Addendum 22: Regulation No. 23

Revision 3 – Amendment 4

Supplement 18 to the original version of the Regulation - Date of entry into force:
18 November 2012

Uniform provisions concerning the approval of reversing and manoeuvring lamps for power-driven vehicles and their trailers

Figure 4
Marking for a manoeuvring lamps

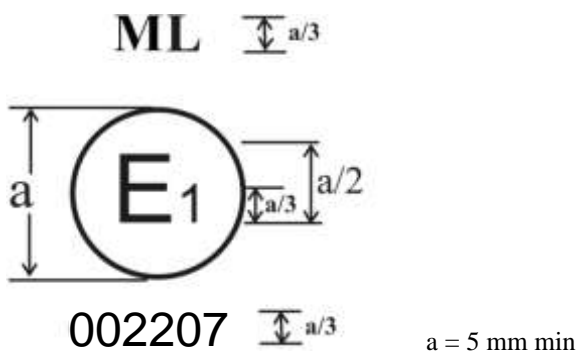
Annex 2, amend to read:

The device bearing the approval mark shown above is a manoeuvring lamp approved in Germany (E1) pursuant to Regulation No. 23 under approval number 2207.

The approval number indicates that the approval was granted in accordance with the requirements of Regulation No. 23 in its original form.

Note: The approval number and additional symbol shall be placed close to the circle and either above or below the letter "E" or to the left or right of that letter. The digits of the approval number and of the production serial number shall be on the same side of the letter "E" and face the same direction. The use of Roman numerals as approval numbers should be avoided so as to prevent any confusion with other symbols."
